THE CLEVELAND ELECTRIC ILLUMINATING COMPANY

PY-CEI/NRR-0010 L

Perry Nuclear Power Plant
Bracket Nos. 50-440; 50-441
SER Outstanding Issue No. 9
Pool Dynamic Loads

APPENDIX 3B
CONTAINMENT LOADS

FIGURE I-1

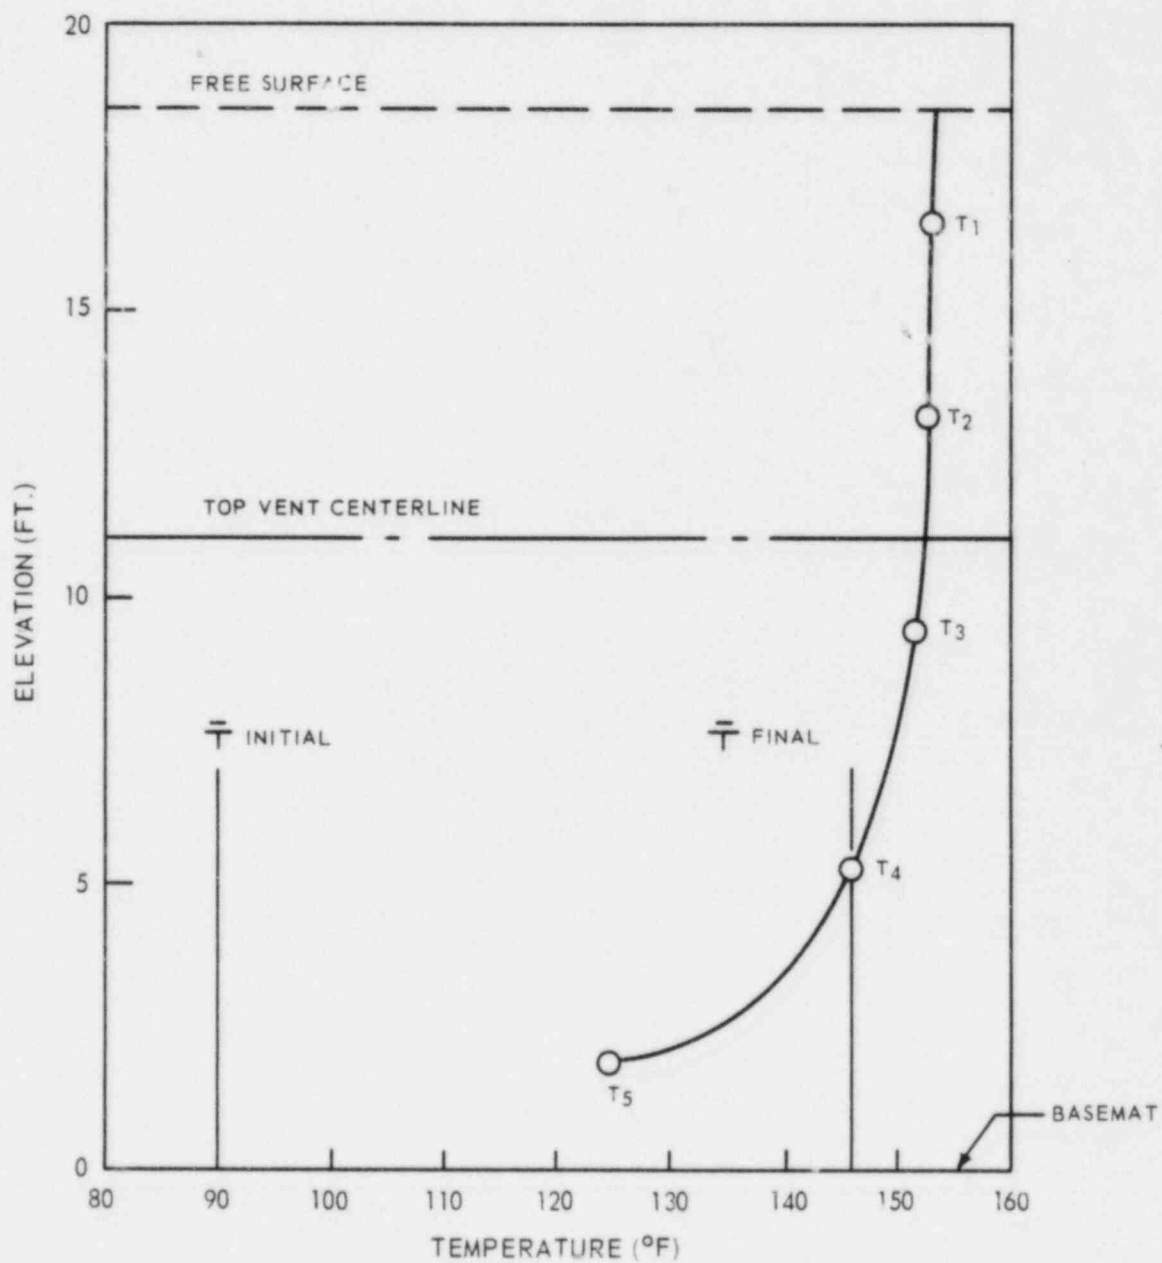
FSAR Figure I-1 shows the suppression pool temperature profile for large breaks at Perry.
